1 September 2022

National Trust objection relating to SSD-31179510 Gregory Place Build-to-Rent

Figure 3: Current (left) and proposed (right) views of Hambledon Cottage show the true impact of this proposal. It in no way can be considered Low/Moderate as claimed by the Visual Impact Assessment. The Trust call for an accurate and comprehensive view impact assessment to be produced.

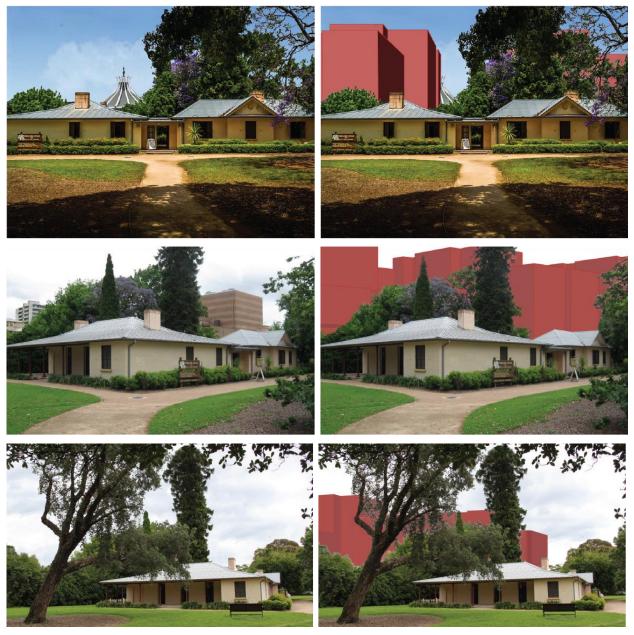
Figure 2: Viewpoints 1 and 2 from the Visual Impact Assessment – taken from across a road with four lanes of traffic – are supposed to illustrate the visual impact of this proposal on Hambledon Cottage. They are not sufficient for this purpose.

We totally dispute the claim in the Visual Impact Assessment (p.15) that the visual impact on Hambledon Cottage is Moderate/Low, and the argument that "Hambledon Cottage is subservient to the existing vegetation of the SHR." Hambledon Cottage, Elizabeth Farm and Experiment Farm are not "subservient" to vegetation. They are (individually and collectively) a rare grouping of colonial landscapes, including houses, trees and gardens, that together form a distinctive landscape. The tall Hoop and Bunya Pines are there *because* of Hambledon Cottage, not the other way around.

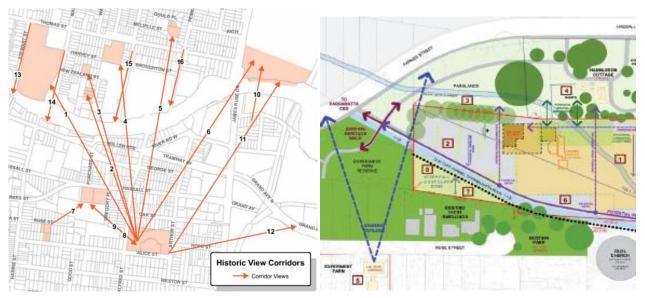
Incredibly, the Visual Impact Assessment (p.15) only assesses "selected viewpoints selected based on public viewing points around the site." It does not assess any of the identified historic view corridors for Harris Park that are identified in the 2011 Parramatta DCP, shown in Figure 4 below.

Figure 4: The historic view corridors for Harris Park are clearly identified in the 2011 DCP (left) where View 7 is the view east from Experiment Farm to Hambledon Cottage. This is vastly different to the "site analysis" presented in the documentation for the project, which narrows the viewing angle from Experiment Farm and does not even consider Elizabeth Farm. (Sources: Map A2.1.1 Historic View Corridors, 2011 Parramatta DCP; Site Analysis by Stanisic Architects)

The National Trust feel that a proper accurate and legitimate Visual Impact Assessment of this proposal must be produced and the public exhibition period recommenced with this information made available.
